REBUTTAL OF STATEMENT BY COUNCILLOR RELF

HIGHWAYS MATTERS

ON BEHALF OF THE APPELLANT, HALLAM LAND MANAGEMENT

LAND AT JUNCTION OF NEWARK ROAD, COXMOOR ROAD,
SUTTON IN ASHFIELD, NOTTINGHAMSHIRE

Figure 1: 1.86km walking distance from the station to the southern part of the site

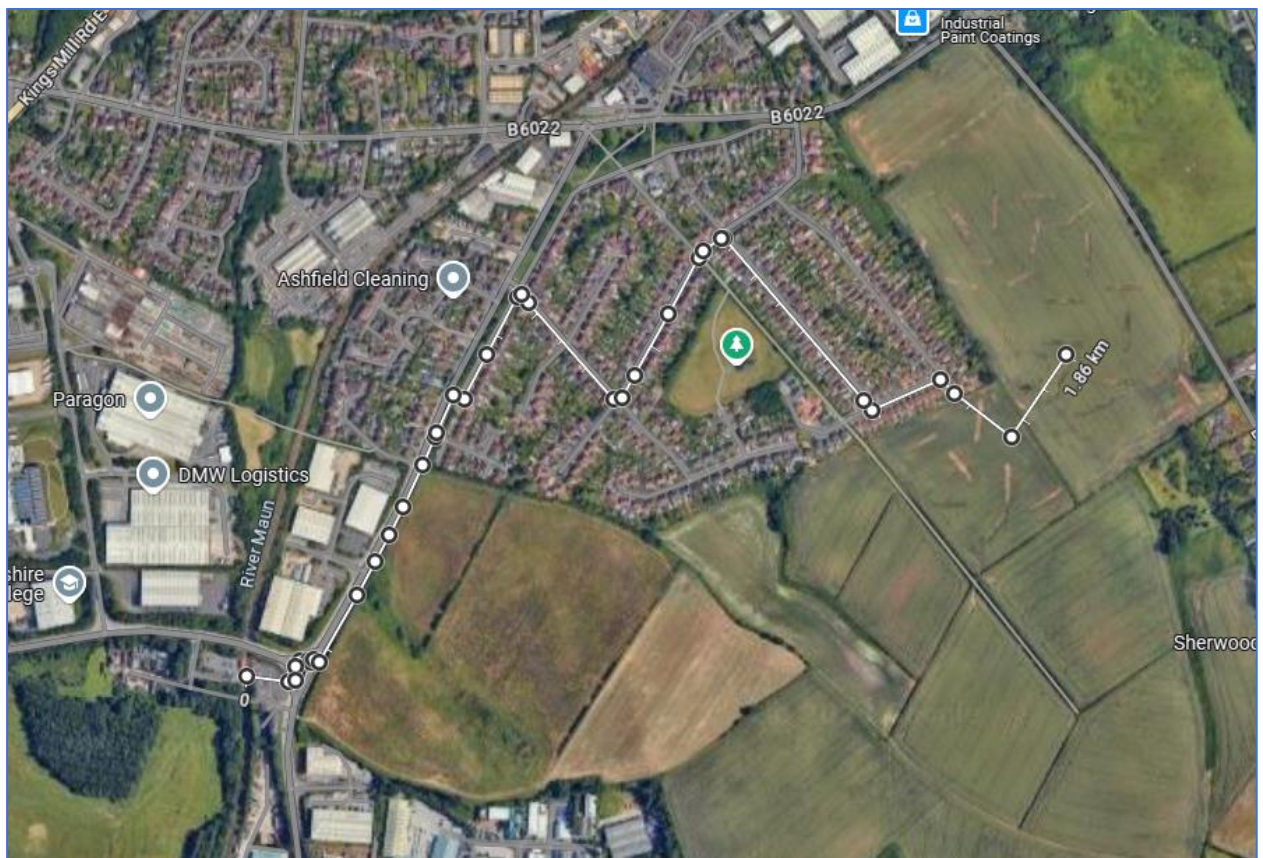
2.1 Councillor Relf states that because of the changed bus route, and the walking distance to the Sutton Parkway train station, “*all households on the proposed development would almost certainly be entirely reliant upon car transport to reach all services.*”

2.3 There are other walking routes besides the one shown in Figure 4 of my Evidence. For example, the route shown below in **Figure 1** is 1.86km from the southern part of the site via Harby Avenue, Sotheby Avenue, Farndon Road, Kirby Folly Road, and Low Moor Road. All the residents would be within a 2km walking distance of the Sutton Parkway station.

DRAWING ADC1580-DR-016-P01

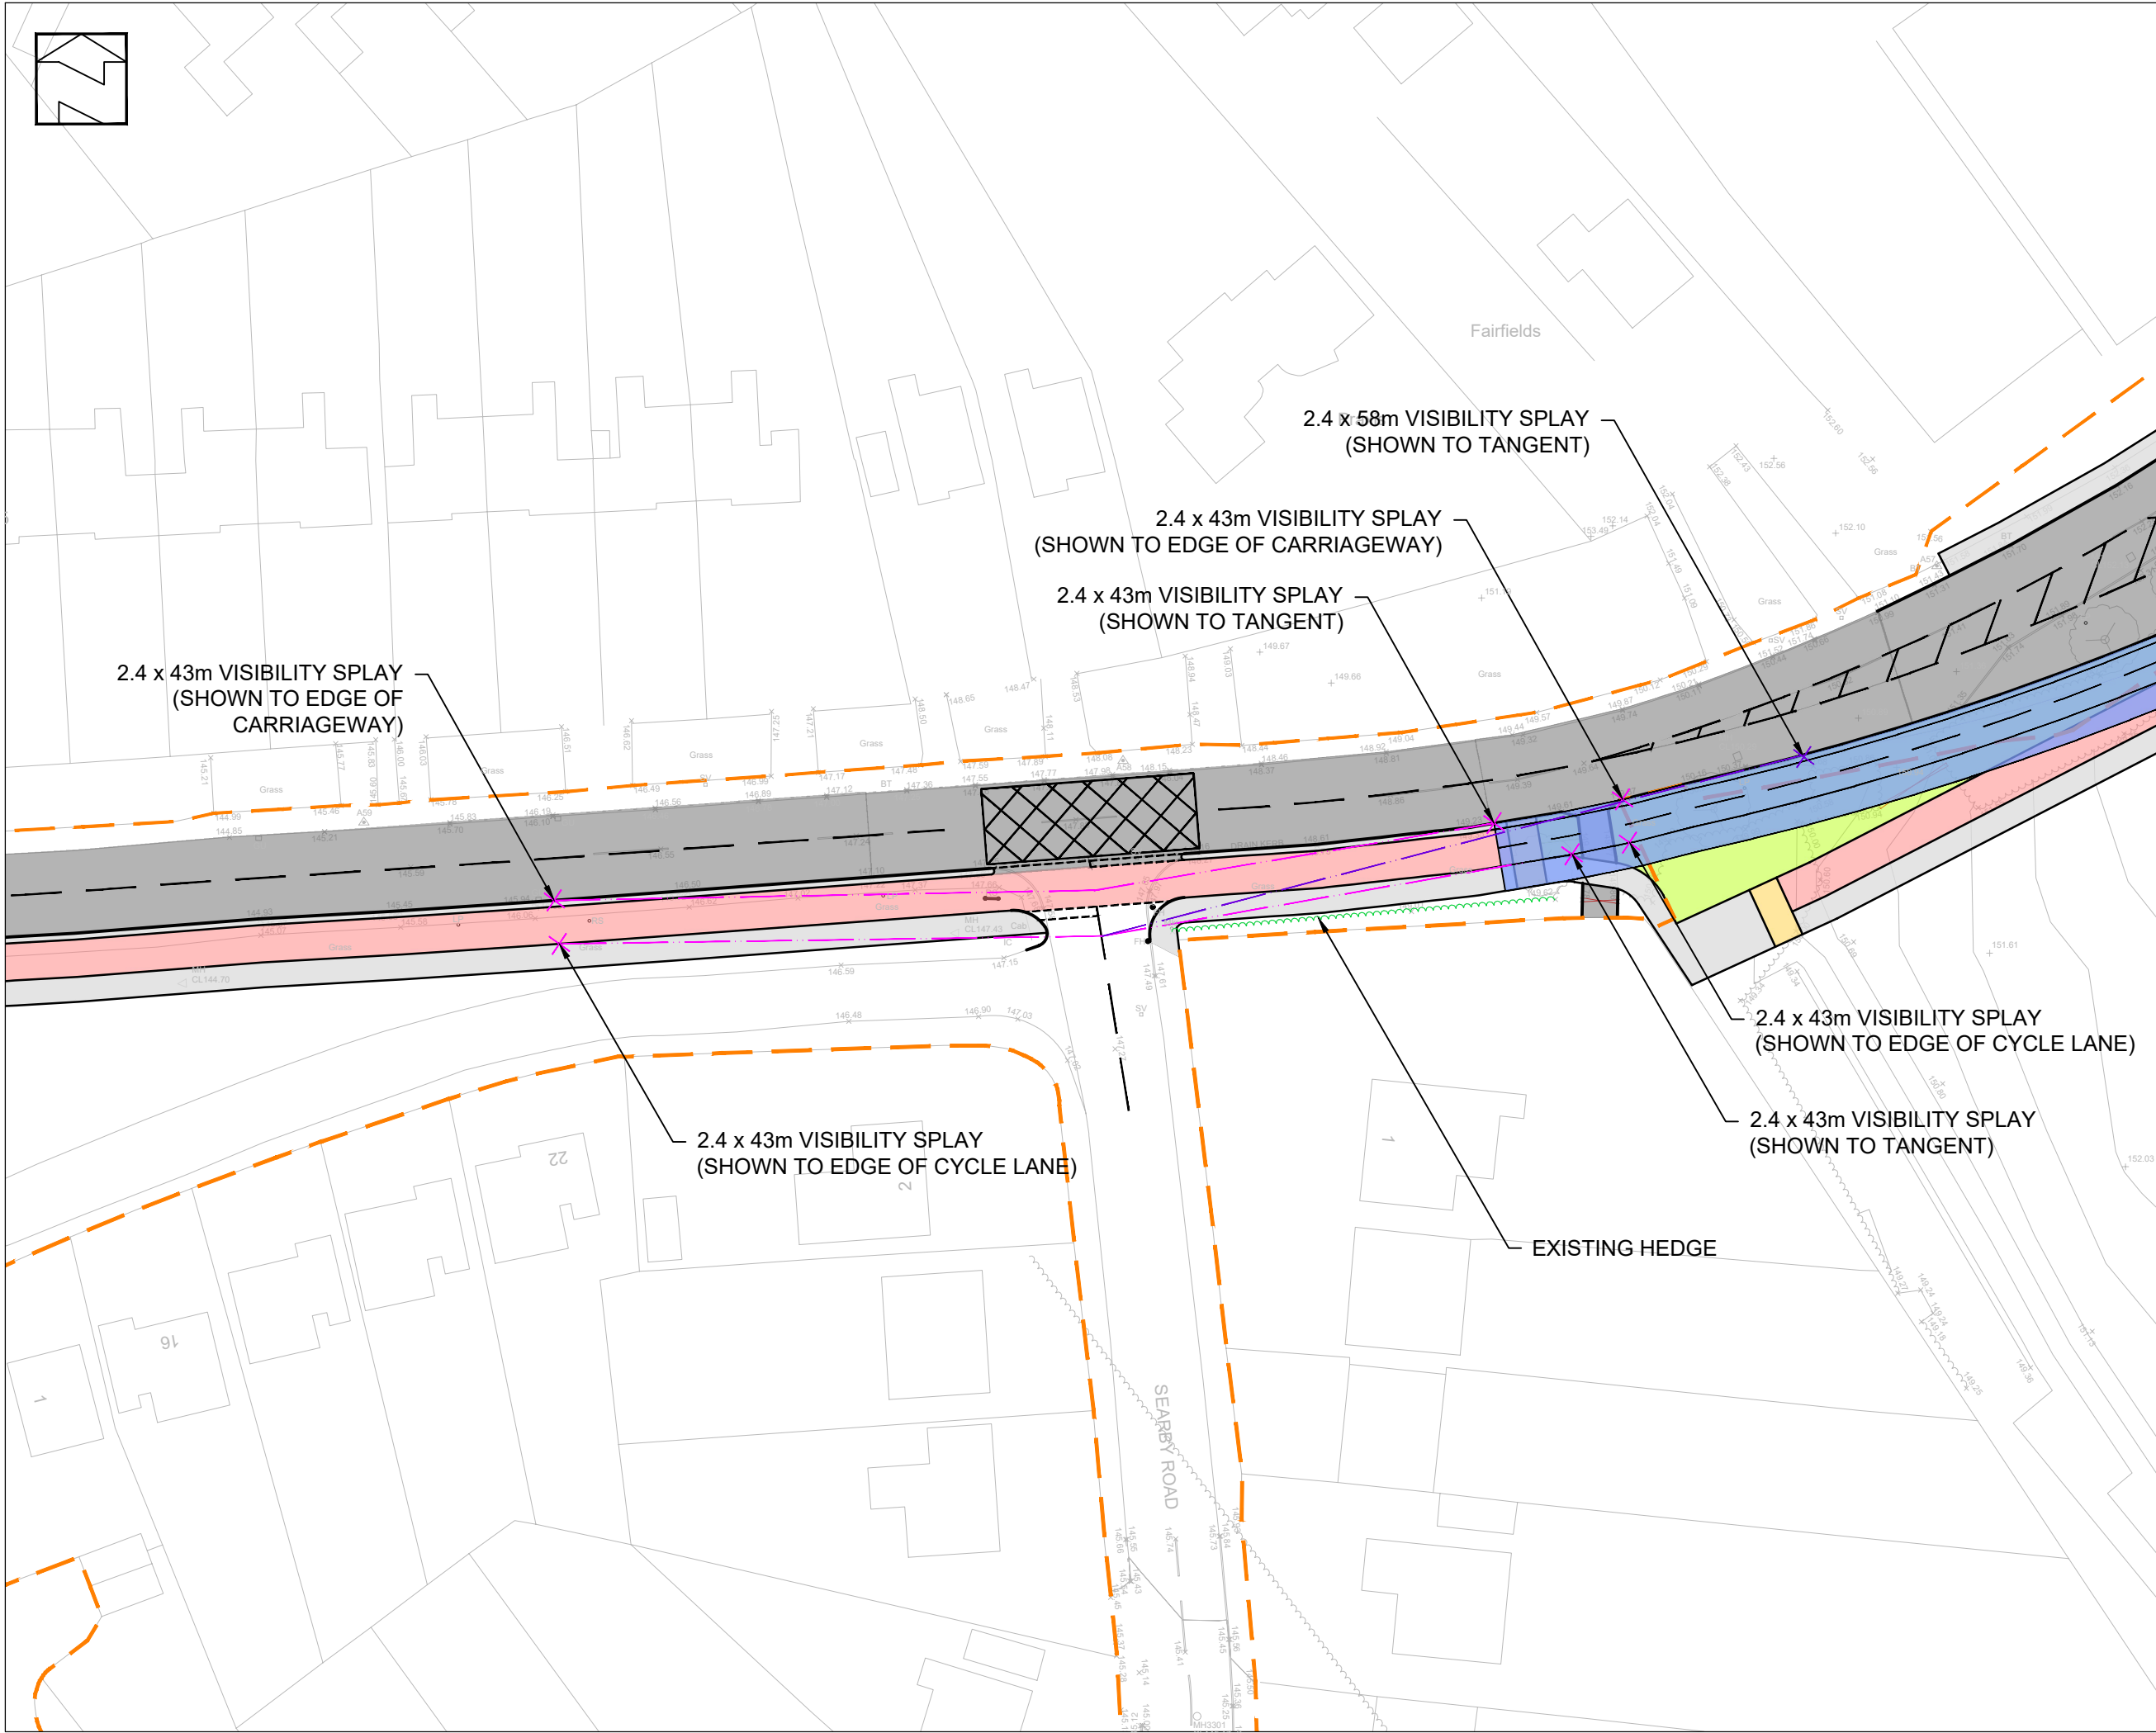
- 4.1 Councillor Relf suggests that drivers emerging from Searby Road and looking right will have insufficient visibility and thus it would be dangerous. That is incorrect, because his driver's view is incorrectly positioned in his photographs.

- 4.2 In **Appendix D** is a new drawing produced for this Rebuttal to illustrate the visibility splays – **Drawing ADC1580-DR-016-P01**. The give-way position on Searby Road's approach to Newark Road is setback 2.4m from the edge of the cycle lane. A 43m visibility splay is shown to the edge of the cycle track, which is the recommended stopping sight distance for speeds of 30mph. Of course, westbound cyclist will be travelling much less than 30mph, but nevertheless the splay is a worst case. The splay would be wholly within the public highway, and unobstructed. Drivers at that location would be able to see cyclists, pedestrians, and vehicles travelling along Newark Road.

- 4.3 An additional splay has been added to the drawing, of 2.4m x 58m, to the tangent of the carriageway edge. The achievable visibility carries on beyond that point and is slightly over 150m in length. It reaches the signal controlled access. That is because Newark Road bends away from Searby Road, increasing the visibility distances. Vehicles, and cyclists, are visible over much more than 43m (**Figure 2**).
